# Access Compliance Report

## Public Rights-of-Way

### (Curb Ramps)

Intersection ID: 14441	Main Street: E_KINGSTON_AV	Cross Street: SPRINGDALE_AV	Location: E
ADA ID: F2C7FDA24773	Ramp Type: Perp	Initial Pass/Fail: Fail	Overall Compliance: No
Severity Score: 12.5			
Codes/Mitigation Info/Possible Solution		Field Measurements/Component Compliance

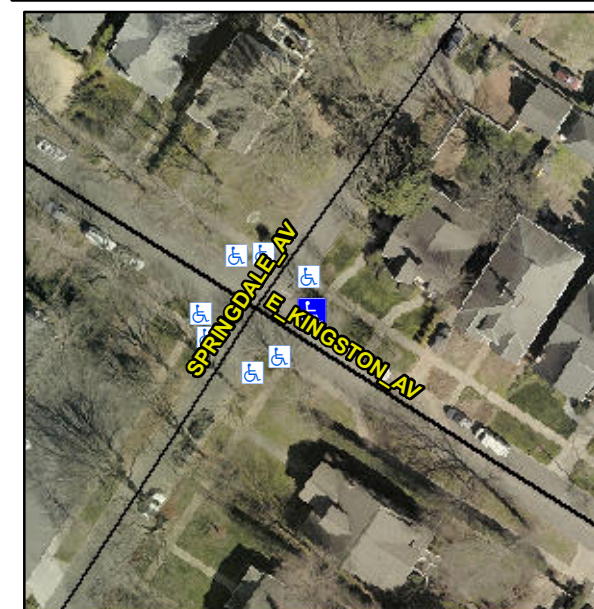
**R304.2.2**

Compliance	Description	Data	Compliance	Description	Data
N/A	Ramp Length (in)	24.0	No	Ramp Slope (%)	9.5
Yes	Ramp Width (in)	53.0	Yes	Ramp XSlope (%)	0.5
N/A	Flare Type LT	N/A	N/A	Flare Type RT	N/A
N/A	Flare Slope LT (%)	N/A	N/A	Flare Slope RT (%)	N/A
N/A	Flare Traversable LT?	N/A	N/A	Flare Traversable RT?	N/A
N/A	Landing Length (in)	N/A	N/A	DWS Provided?	N/A
N/A	Landing Width (in)	N/A	N/A	DWS Contrast?	N/A
N/A	Landing Slope (%)	N/A	N/A	DWS Length (in)	N/A
N/A	Landing X Slope (%)	N/A	N/A	DWS Full Width?	N/A
N/A	Landing Curb? (Y/N)	N/A	N/A	DWS Offset (in)	N/A
N/A	Shared Landing?	N/A			
N/A	Gutter Ponding?	N/A	N/A	Gutter Slope (%)	N/A
N/A	Gutter Lip Ht (in)	N/A	N/A	Gutter X Slope (%)	N/A
N/A	Painted X Walk1?	No	N/A	Painted X Walk2?	N/A
	X Walk 1 Direction	To SW		X Walk 2 Direction	N/A
N/A	X Walk 1 Width (in)	N/A	N/A	X Walk 2 Width (in)	N/A
	X Walk 1 Slope (%)	4.9		X Walk 2 Slope (%)	N/A
	X Walk 1 X Slope (%)	0.5		X Walk 2 X Slope (%)	N/A

**Remove & Replace Entire Ramp.**
